WP-0034  
06/01/2009

## E-TON 40cc Carburetor update

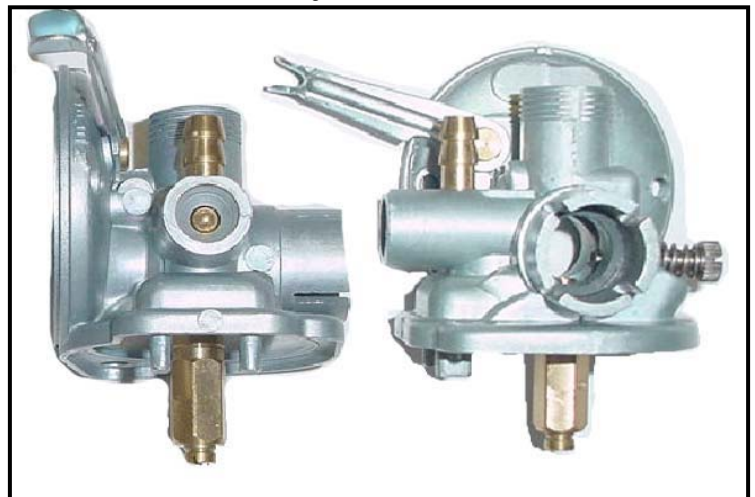
### OLD Style Carburetor

Old style Carburetor **does not** require replacing the inlet pipe.  
Supplied on engine number ending with 010771 or less.

### NEW Style Carburetor

NEW style Carburetor **DOES** require replacing the inlet pipe.  
Supplied on engine number ending with 010772 or greater.

Engine numbers ending with a number lower than 010772 **REQUIRE** replacing this part before installing the new style carburetor.
